## Use by Special Review Staff Report

**PROJECT FILE:** US2023-008

10595 Newlin Gulch Blvd.,  
5th Amendment

SITE PLAN  
 SHEET 3 OF 9  
 JANUARY 30, 2024

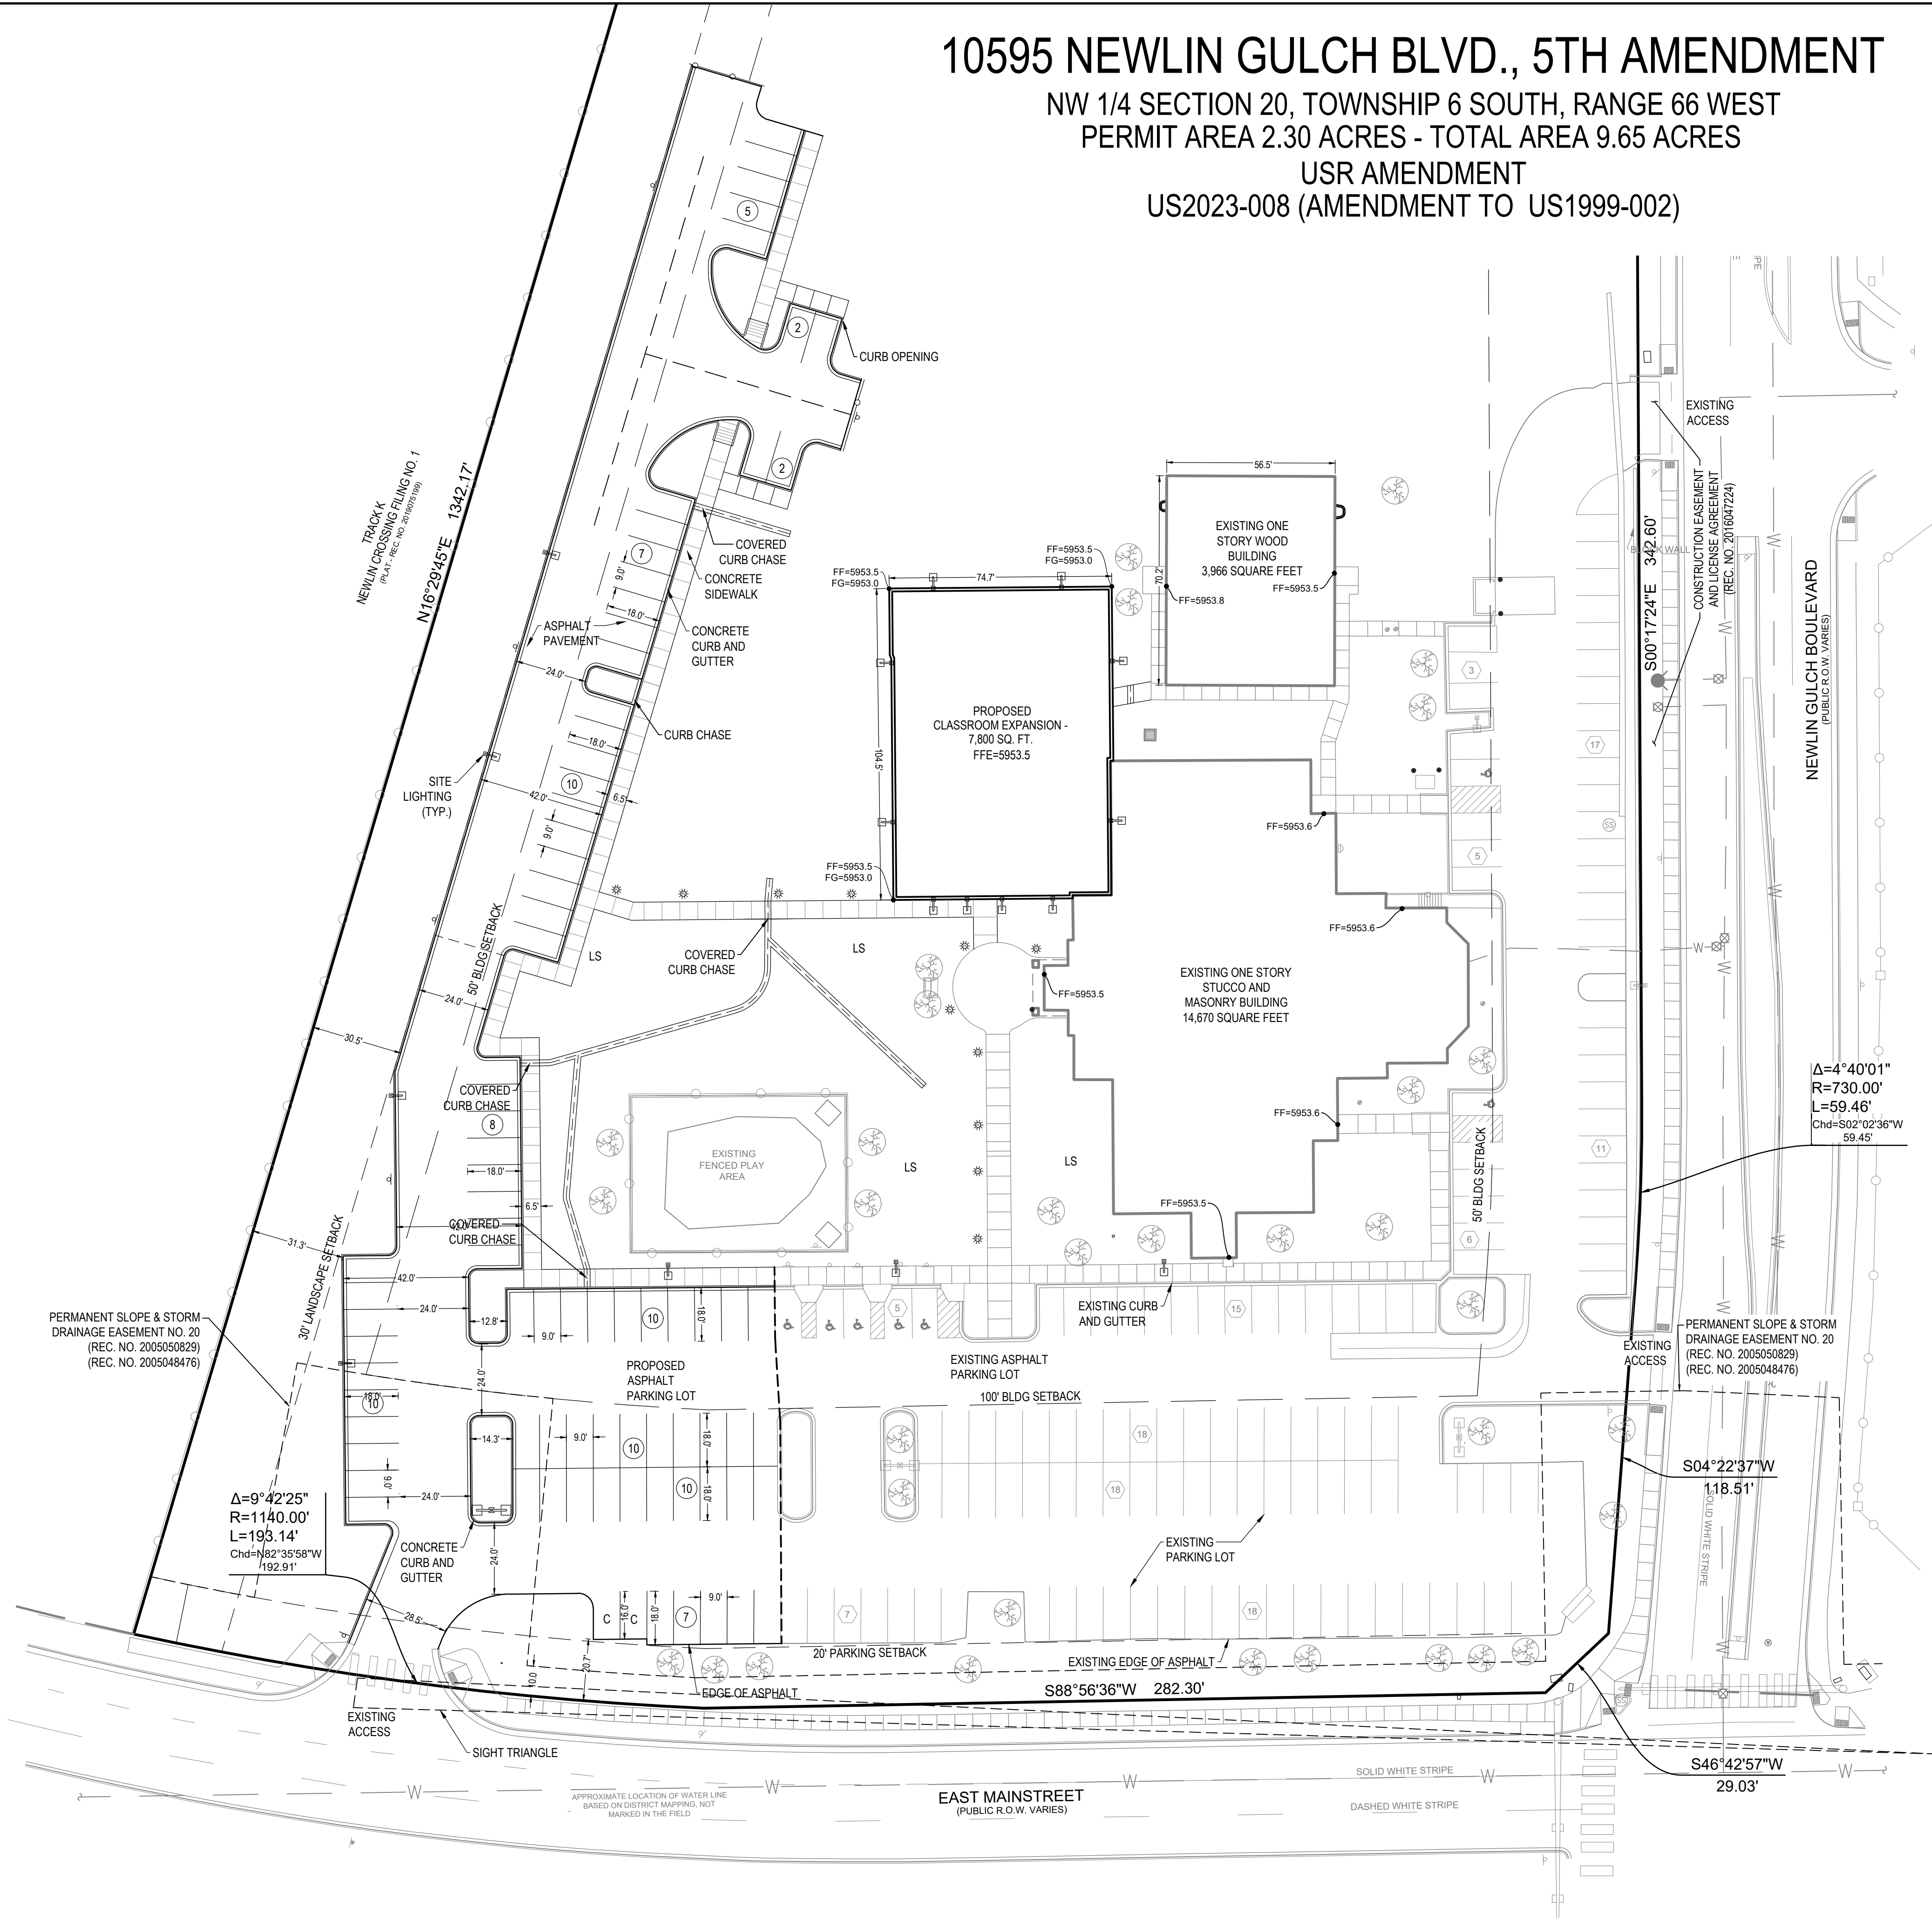
1. Sheets 1-3: Please amend Note #1 in the “General Notes” to remove the language of SIP Improvements in the ROW as no improvements appear to be in the ROW and would likely not be owned by Douglas County (DC).
2. Sheet 4: Please note that this sheet will need to be updated to match the grading plan shown in the GESC Plan portion of the Construction Plans once the review of the plans is complete.

1. Sheets 1-3: Please amend Note #1 in the “General Notes” to remove the language of SIP Improvements in the ROW as no improvements appear to be in the ROW and would likely not be owned by Douglas County (DC). **PDG Response: Text revised.**
2. Sheet 4: Please note that this sheet will need to be updated to match the grading plan shown in the GESC Plan portion of the Construction Plans once the review of the plans is complete. **PDG Response: Grading plan updated to match construction plan.**

GRADING AND DRAINAGE PLAN  
 SHEET 4 OF 9  
 JANUARY 30, 2024

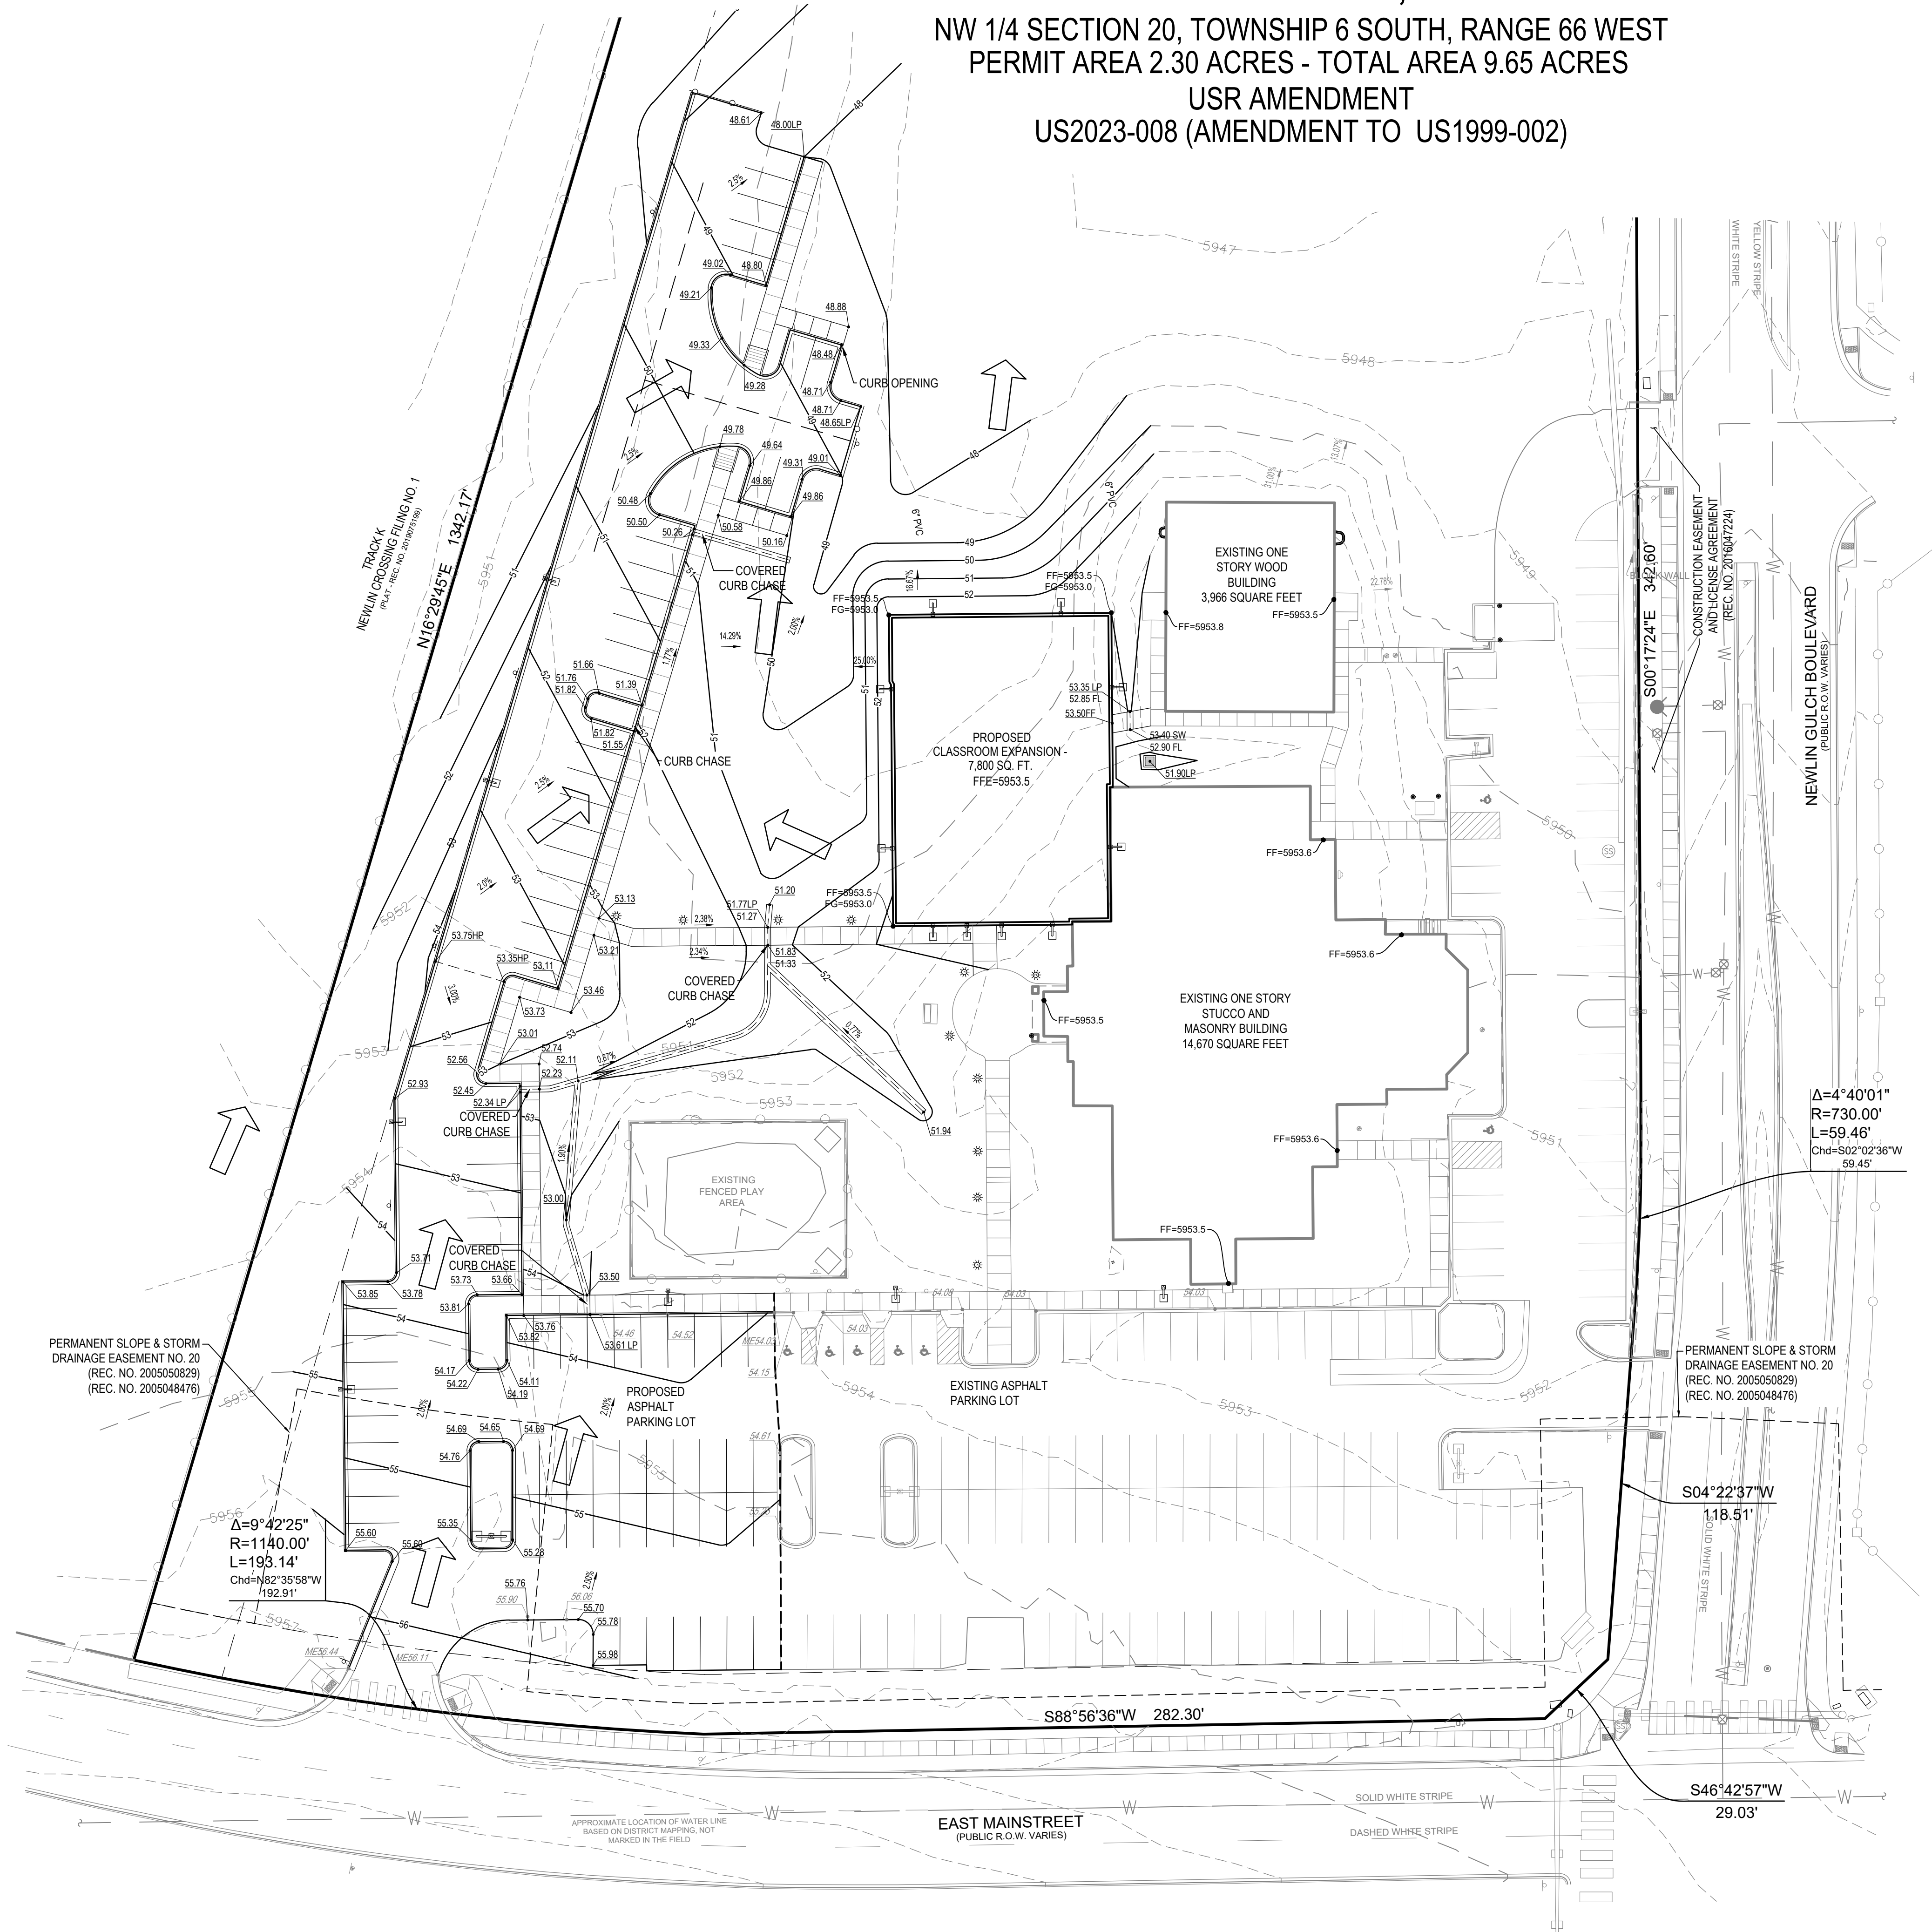
*2. Sheet 4: Please note that this sheet will need to be updated to match the grading plan shown in the GESC Plan portion of the Construction Plans once the review of the plans is complete.*
